Indian Street Commerce Center Final Environmental Impact Report

Prepared for City of Moreno Valley

November 2016

Indian Street Commerce Center Project

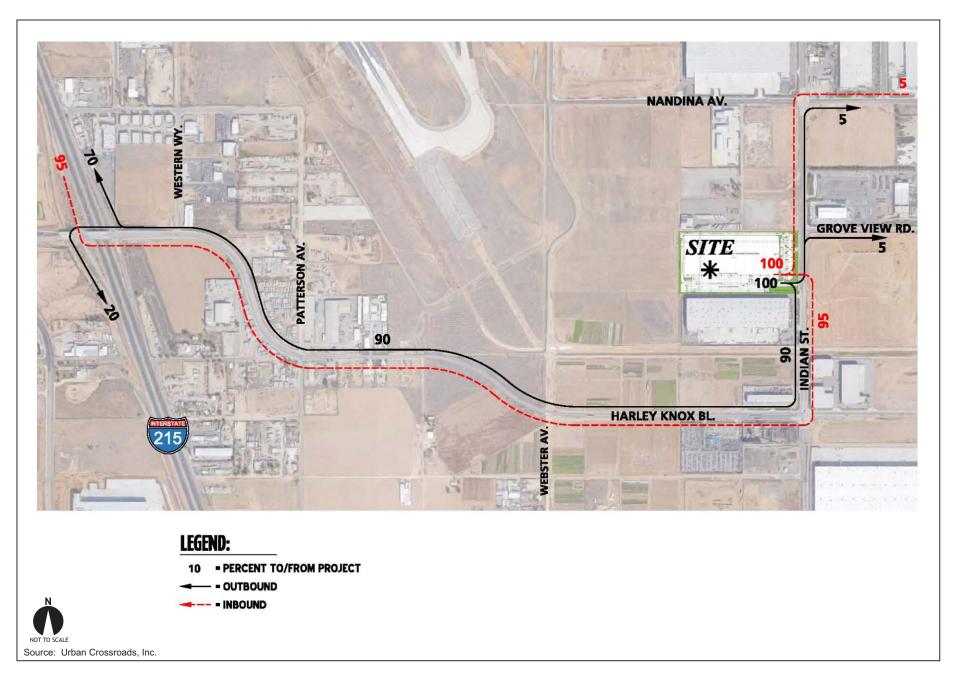
The commentor incorrectly represents Trip Distribution information provided in the EIR. Specifically, the commentor states "the Traffic Impact Analysis anticipates 95% of the inbound truck trips to be from SR-60 to I-215 southbound. There is no reason for this finding when the EIR assumes 20% of trips would be traveling north from San Diego." The EIR does NOT assume 20% of trips would be traveling north from San Diego.

Project Truck Distribution is graphically depicted at EIR Figure 4.1-7 (TIA Exhibit 4-2), reproduced on the following page. As indicated, 95 percent of the inbound trips would access the Project via southbound I-215. Twenty percent of the outbound trips would travel southbound via I-215. Contrary to the commentor's assertion, there is no assumed "20% of trips would be traveling north from San Diego."
